TECHNICAL SERVICE BULLETIN

NO. 73-A-5

SUBJECT:

THROTTLE CABLE

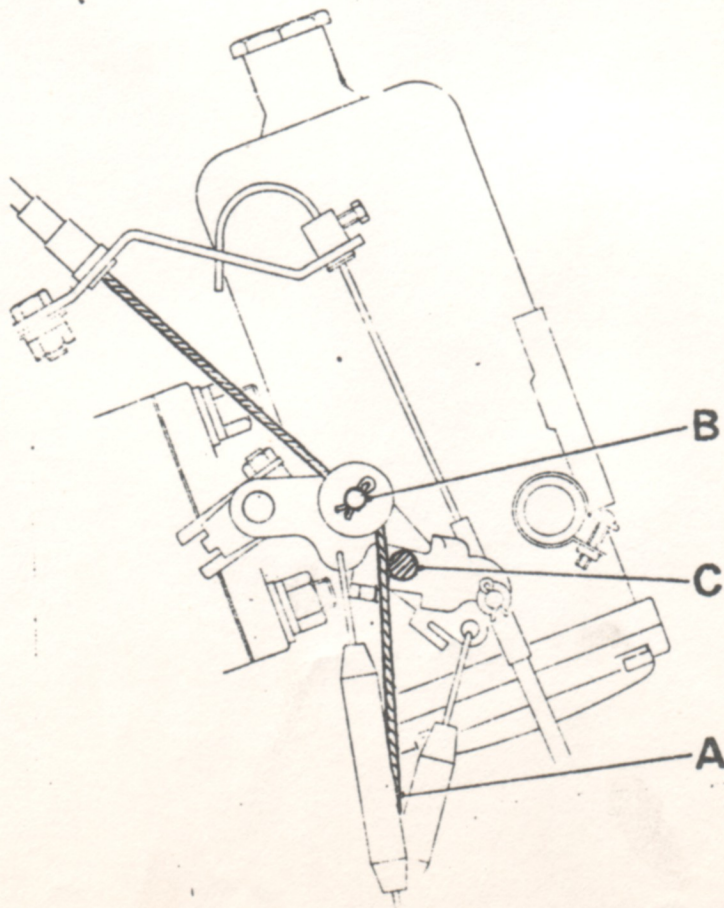
When replacing carburetors on these models, insure that the free end (A) of the throttle cable below the throttle cable trunion (B) cannot interfere with the free operation of the throttle; it is essential that it be routed on the engine side of the choke lever spindle (C).
